RESPONSE TO REQUEST FOR ADDITIONAL INFORMATION

APR1400 Design Certification

Docket No. 52-046

RAI No.: 357-8344
SRP Section: 06.02.04 – Containment Isolation System
Application Section: 6.2.4
Date of RAI Issue: 01/05/2016

Figure 6.2.4-1 Containment Isolation Valve Arrangement (Sheet 1 of 13)

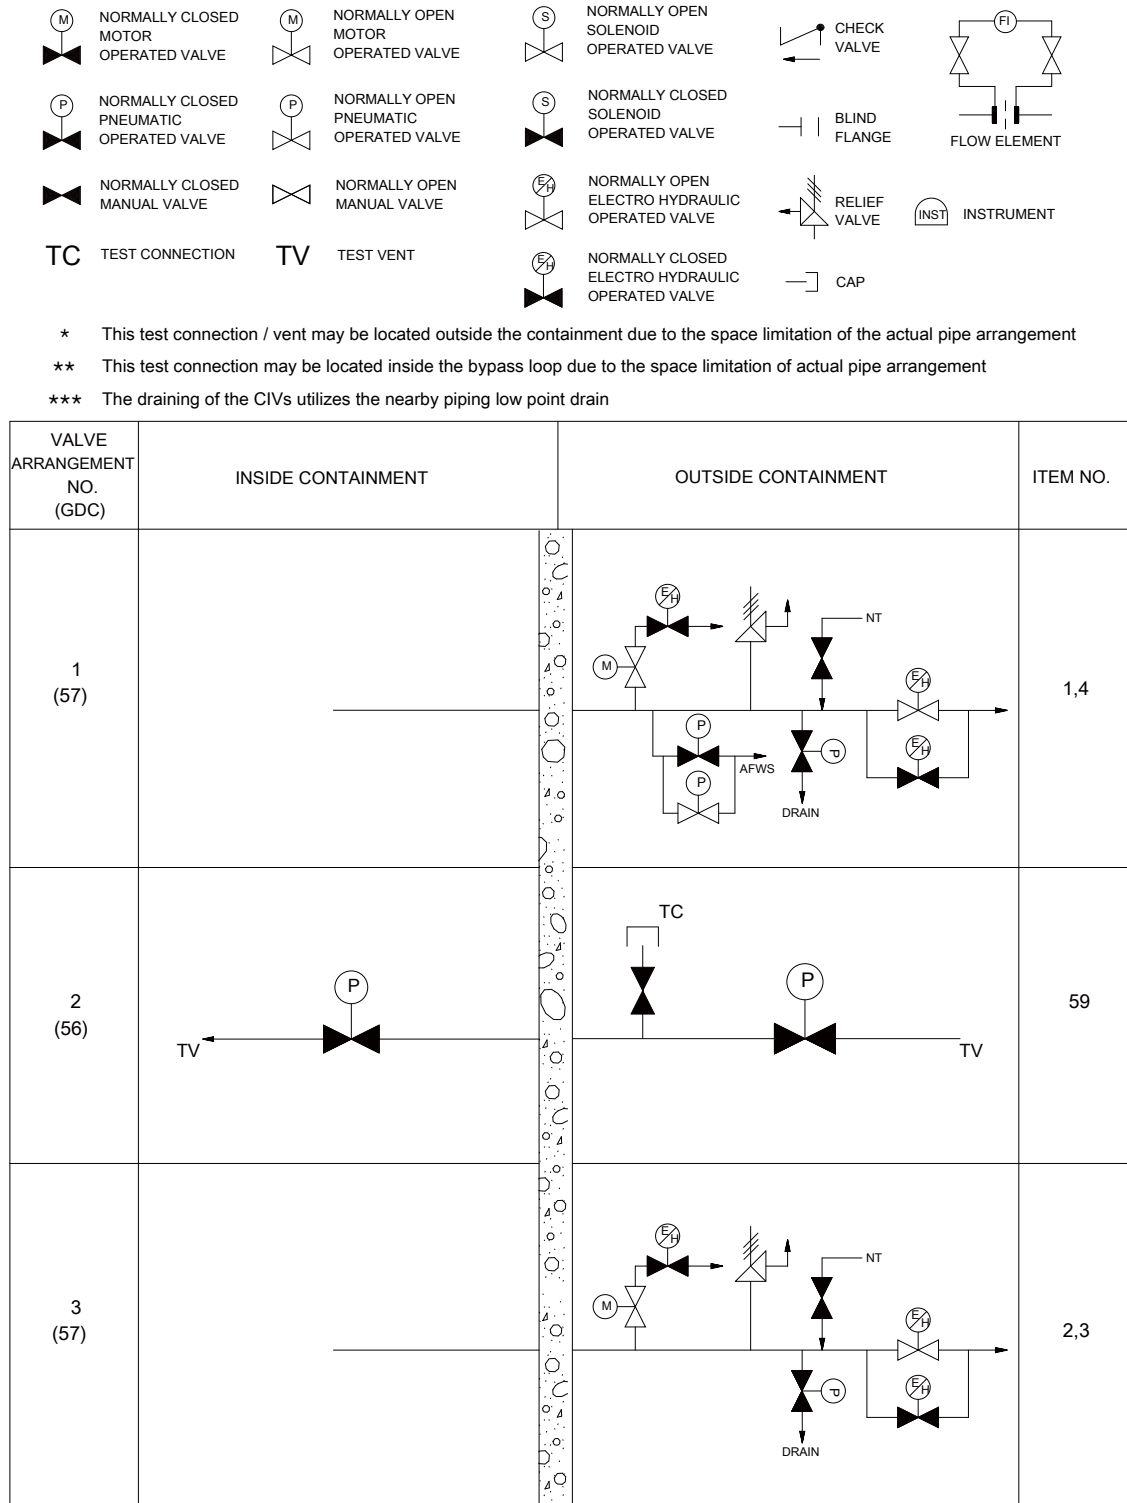
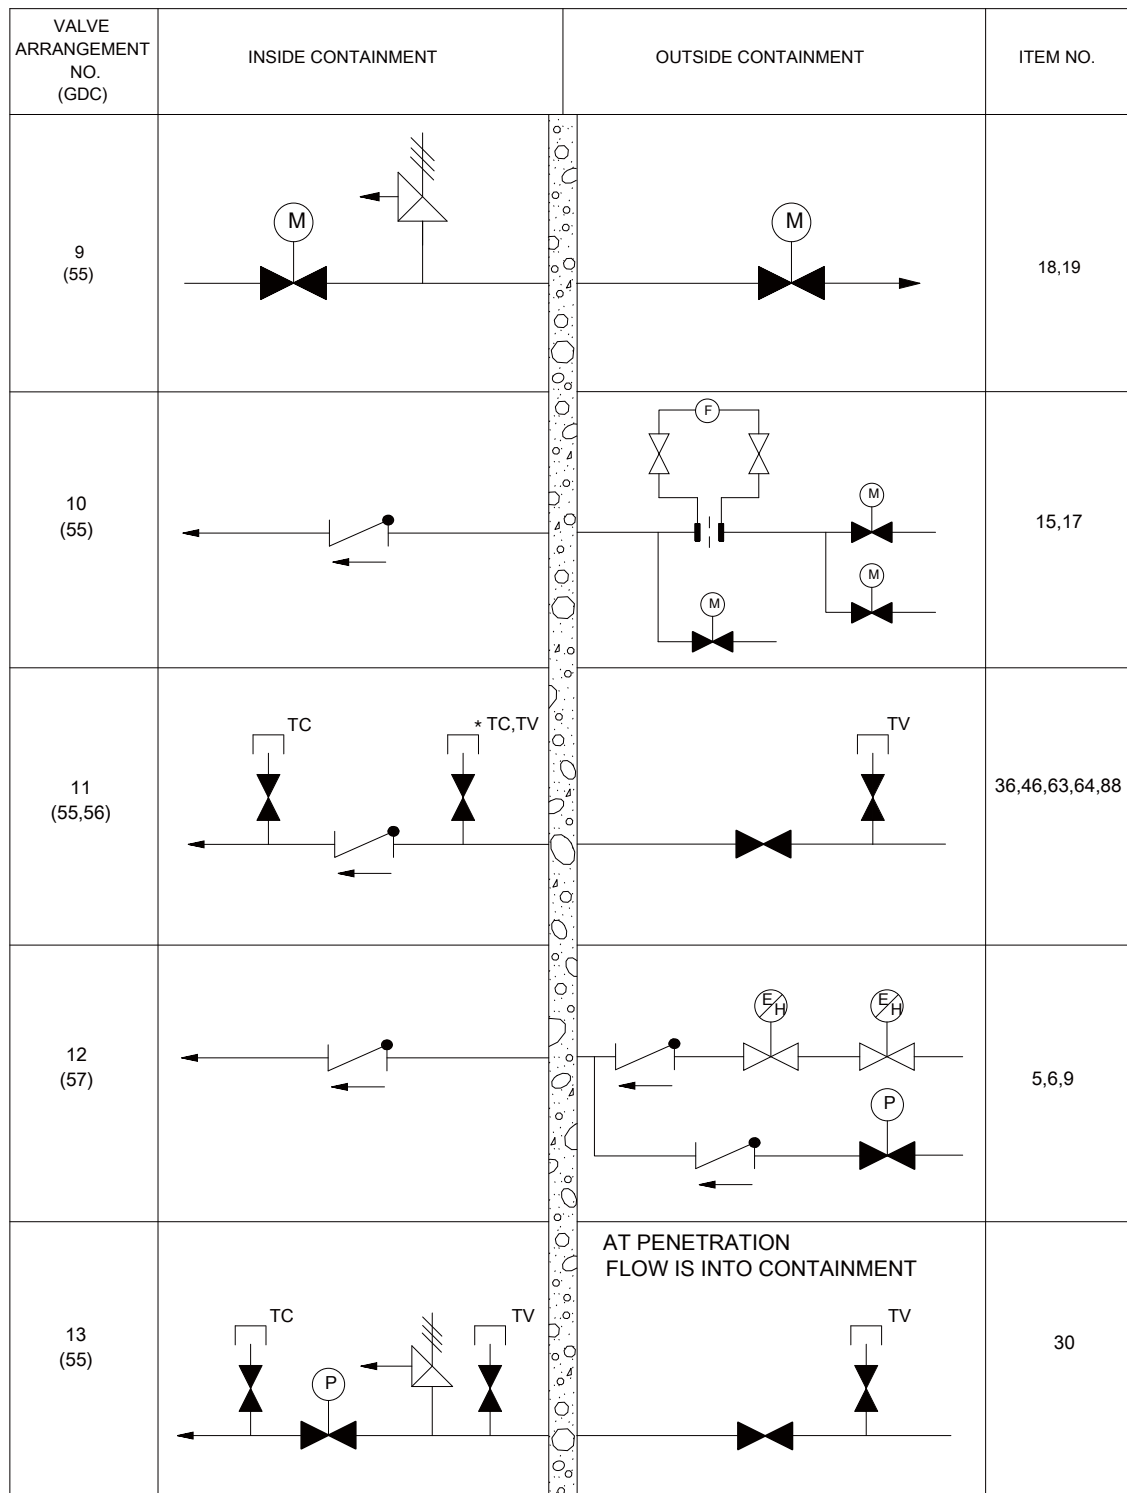
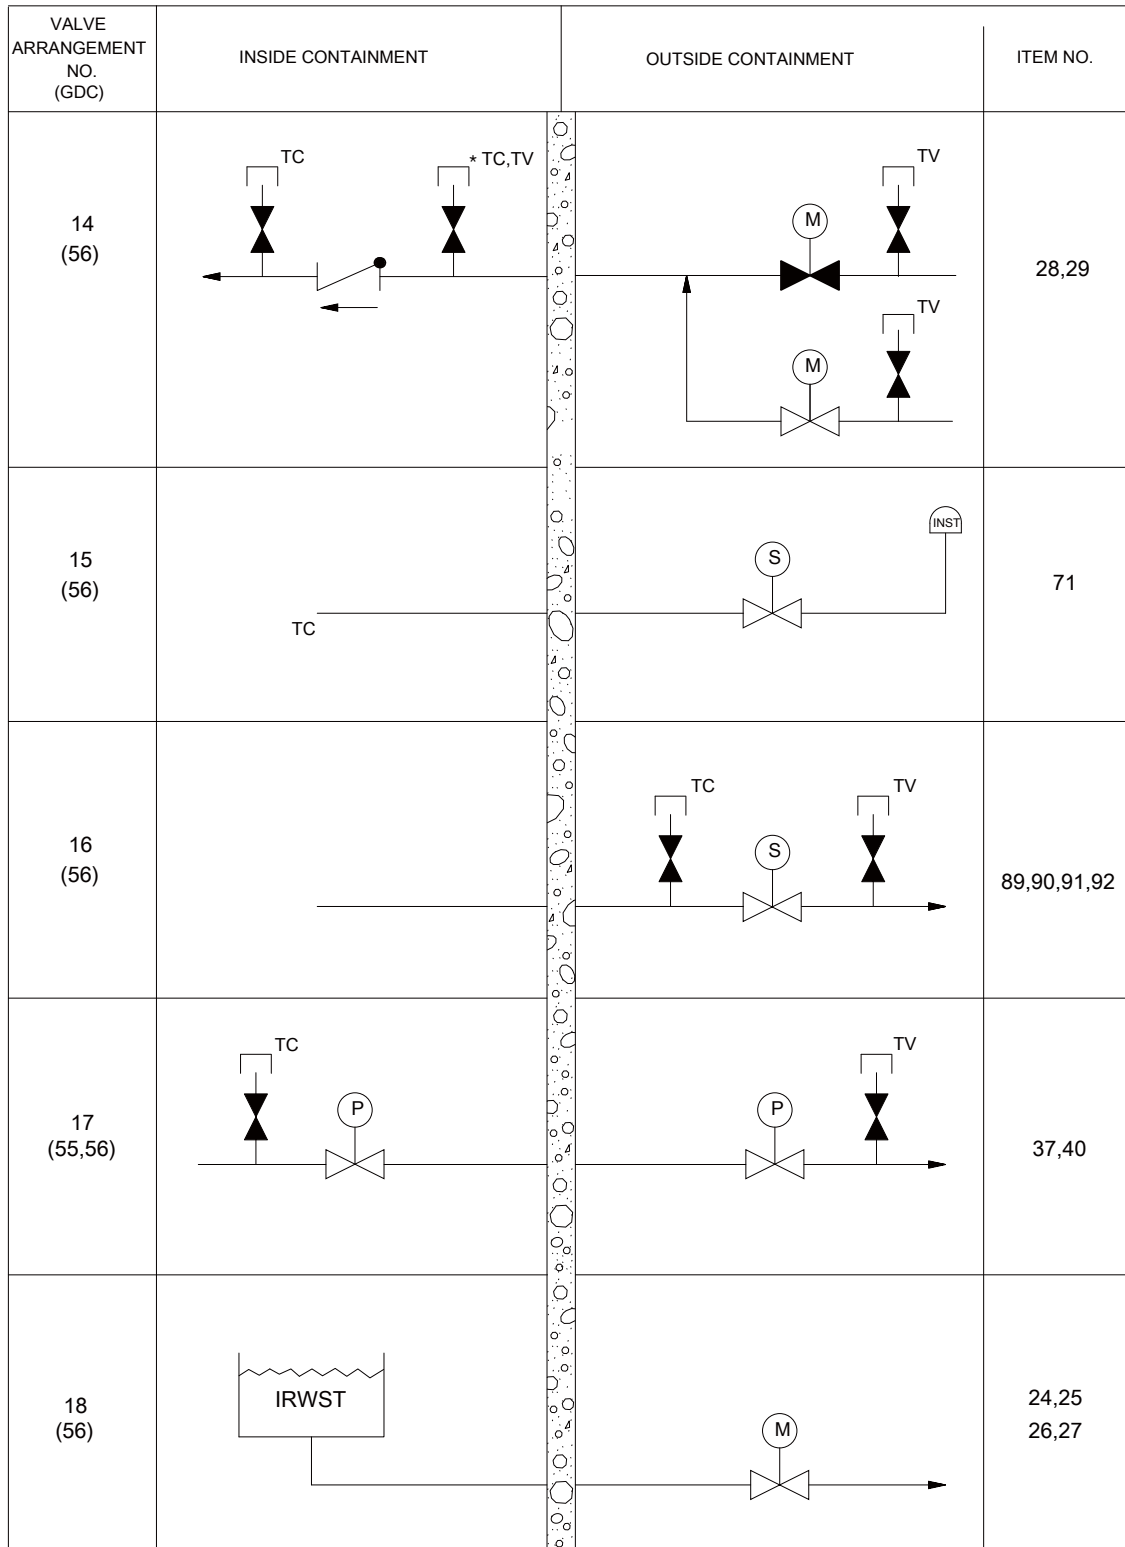
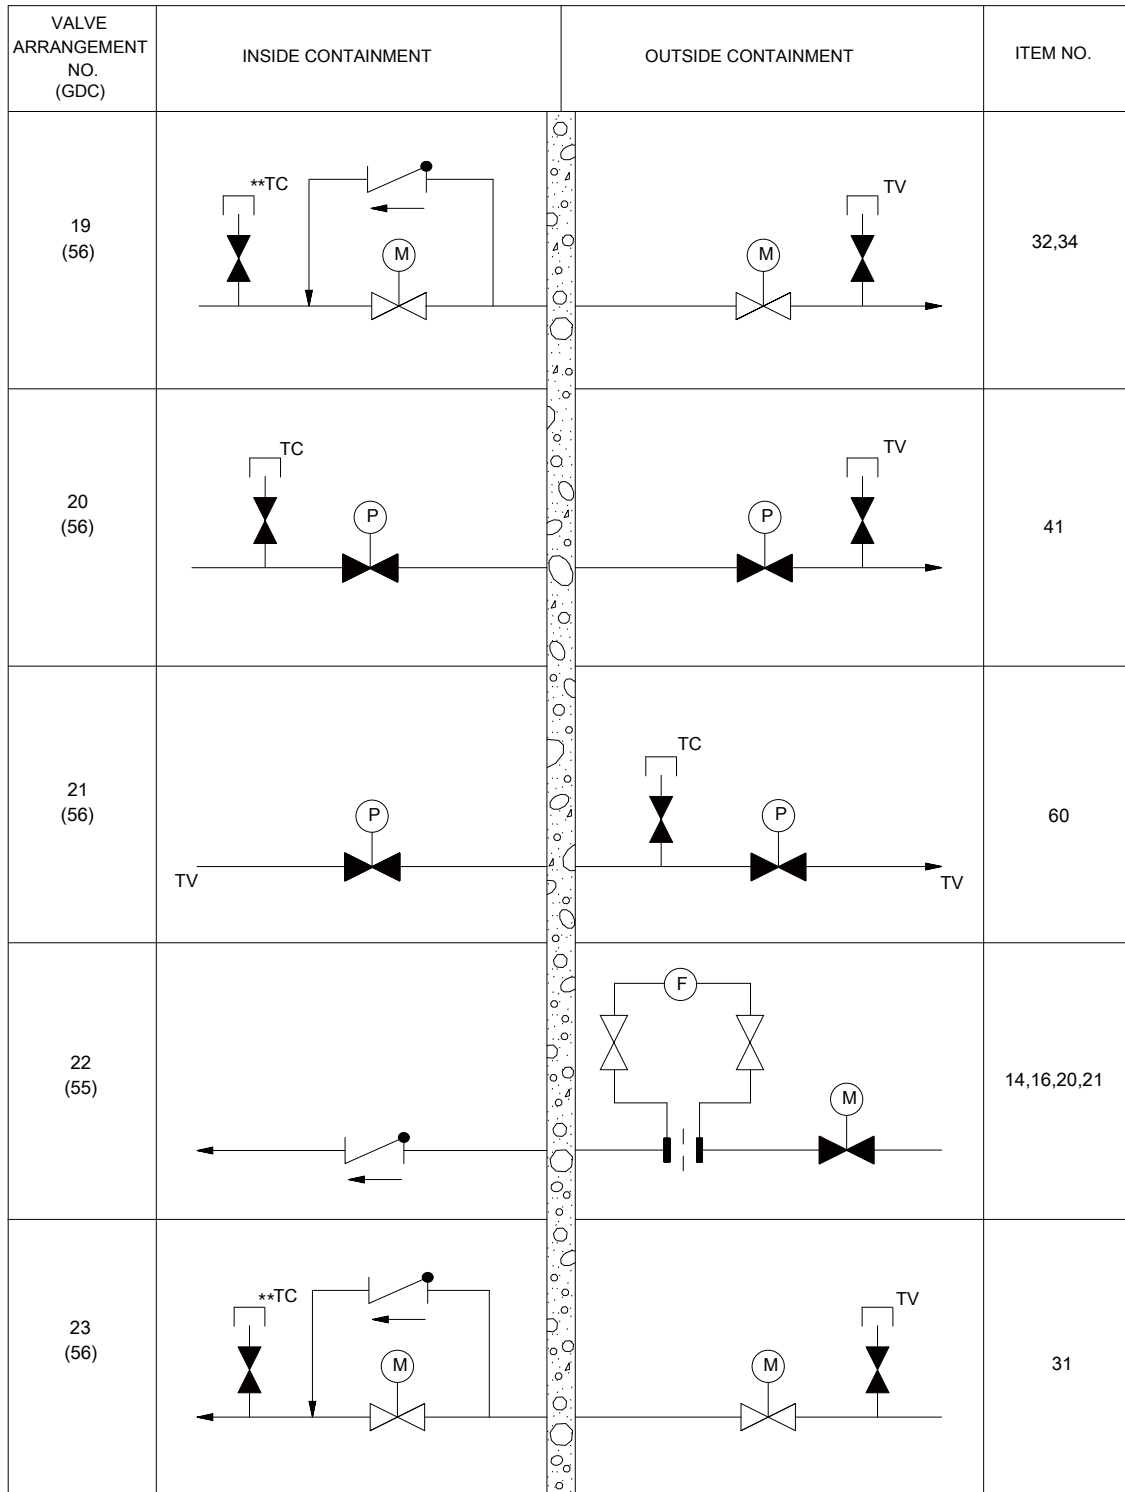
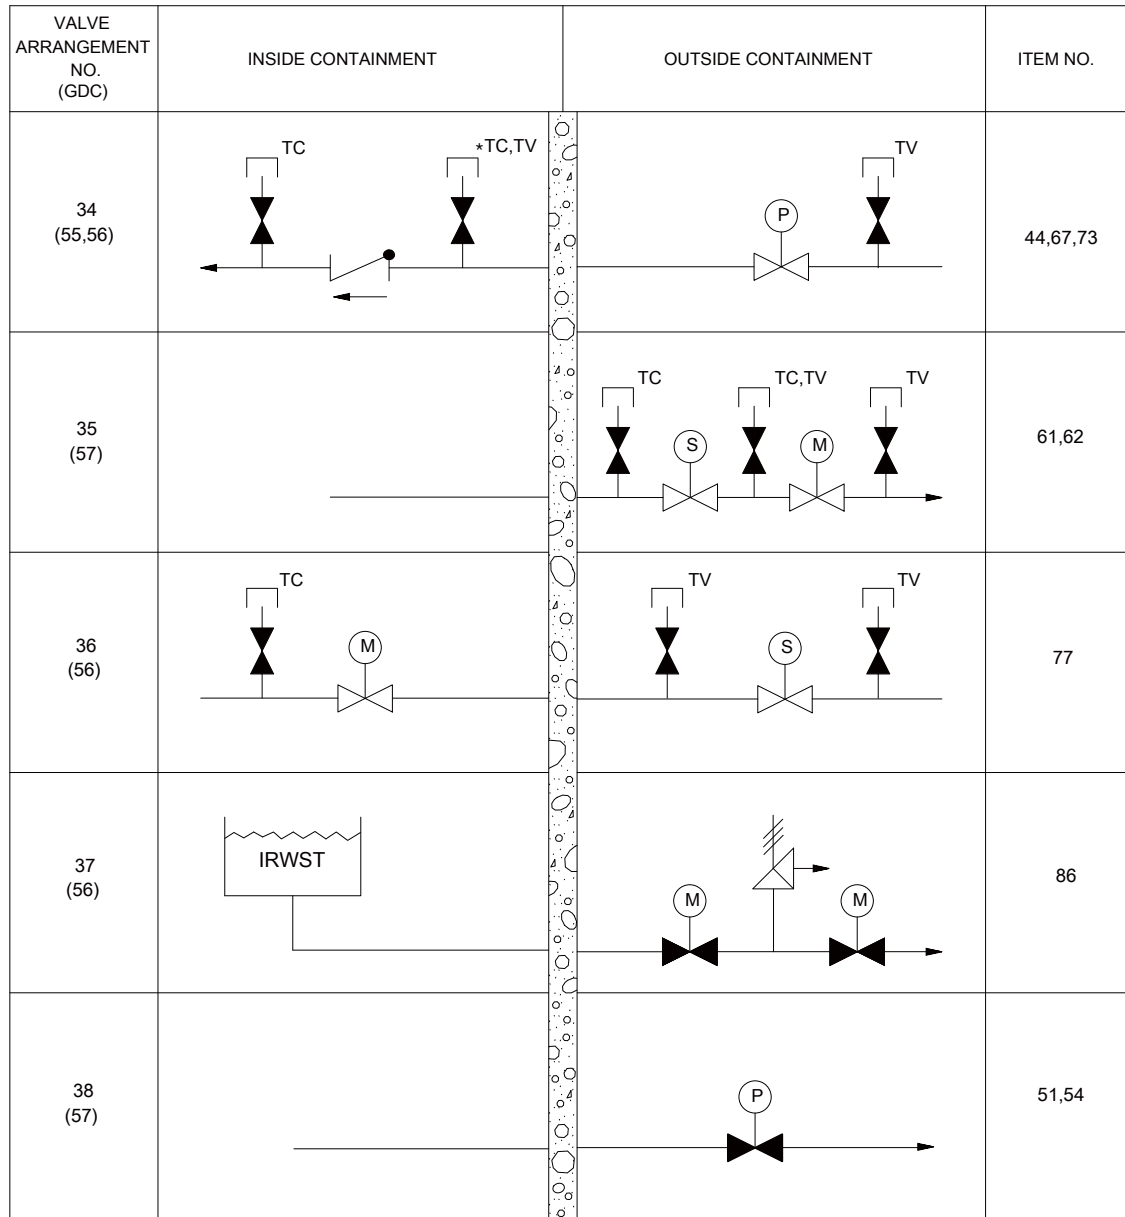
Provide a table describing the provisions for individual leakage rate testing of the isolation barrier.

In order to evaluate if requirements of General Design Criteria (GDC) 54, as it relates to the ability to test the operability of isolation barriers, are met and to determine if valve leakage is within acceptable limits, for each containment isolation barrier, provide a table in the DCD describing the provisions (test connection etc.) for individual leakage rate testing of the barrier.

DCD Tier 2, Figure 6.2.4-1 will be revised to include the leak rate test connections and locations for associated valves, vents, and drain connections along with the locations of the applicable CIVs. Table 6.2.4-1 contains a list of all containment isolation valves (CIVs) including a designation of the test type for each individual valve. Table 6.2.4-1 also includes reference to the valve arrangements depicted in Figure 6.2.4-1. A detailed discussion regarding the Type C test is presented in DCD Tier 2, Subsection 6.2.6.3. The replacement figures provided in Attachment 1 delineate the test connections for the individual CIVs for leakage measurement. This was determined to be a more appropriate means of depicting the associated test connections; a separate table also describing the test connections would be redundant and is considered unnecessary.

DCD Tier 2, Figure 6.2.4-1 and DCD Tier 1, Figure 2.11.3-1 will be revised, as indicated in the attachments associated with this response.

- DCD Tier 2, Figure 6.2.4-1 (Attachment 1)
